# **A795 Ambridge Bypass Safety Scheme Stage 2 Road Safety Audit**

<b>Document Title</b>	A795 Ambridge Bypass Safety Scheme Stage 2 Road Safety Audit
<b>Author</b>	Michael Juan
<b>Reference Number</b>	AMB-RSA-S2/06/21
<b>Owner</b>	Highways England - South West Region - Road Safety Team
<b>Revision</b>	1.0
<b>Document Status</b>	Final
<b>Control Date</b>	21 June 2021

2.1.6 The scheme is to introduce safety improvements and involves the installation of additional traffic signs, amendment to road markings and VRS improvements along the recently constructed Bypass.

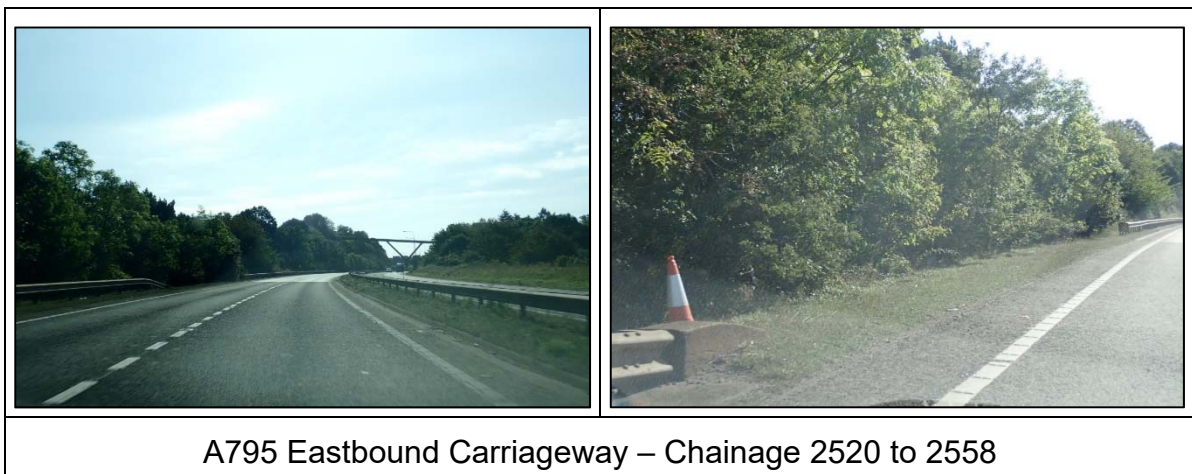
Location A: A795 Stowford Junction – Southbound Approach

Summary: Insufficiently specified vegetation clearance, increasing the risk of injury with loss of control type collisions.

The location of the southbound off slip is located on a gradual left-hand bend and is obscured by the current vegetation after the Advance Directional Sign. This vegetation, which is not in leaf, is also partially obscuring the countdown markers on the approach for this junction and could also obscure the visibility of the proposed Direction Sign. The vegetation clearance shown in the supplied drawing gives no dimension other than area. This may lead to insufficient vegetation being removed and compromise the forward visibility of the road layout being achieved and road users being unable to appreciate the approaching off slip. This could result in loss of control type collisions, risking injury to vehicle occupants.

It is recommended that extents of vegetation are sufficiently detailed so that the intended vegetation clearance is achieved along the southbound approach, making an allowance for seasonal growth.

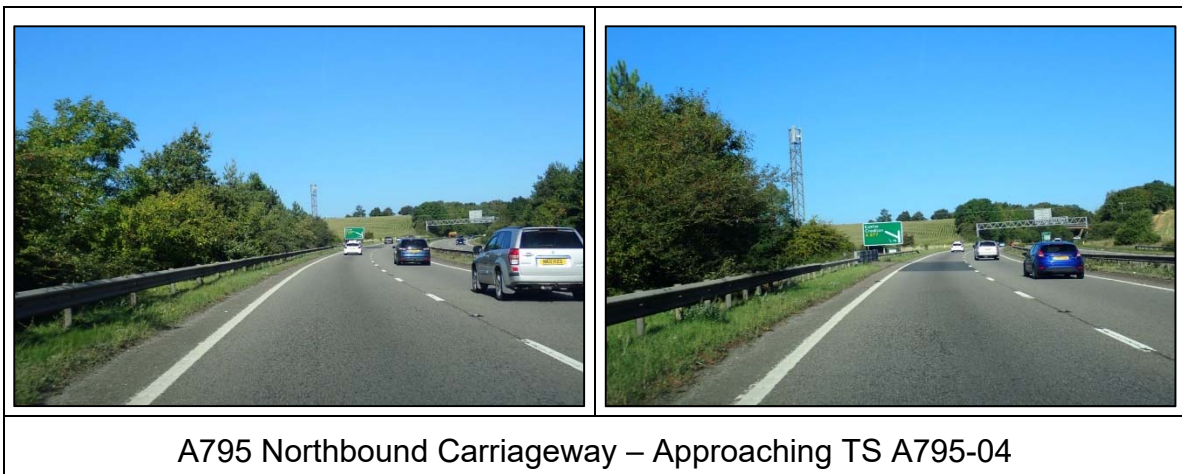
Location E: A795 Stowford Junction – Splitter Island

Summary: Removal of Direction Sign from Splitter Island may lead to late braking and loss of control collisions.

It is proposed to relocate the Direction Sign from its current location on the splitter island to the commencement of the off slip for the junction within the nearside verge. The proposed marker posts for the splitter island may not clearly identify the junction for approaching motorists. During the site visit it was clear that motorists have been involved in loss of control type collisions and have demolished the direction sign and all the chevron signs on the splitter island.

It is recommended that the splitter island for approaching motorist is clearly identifiable, for example by replacing the existing chevrons signs on the splitter island with a more durable set and extending further along the island towards the nosing.
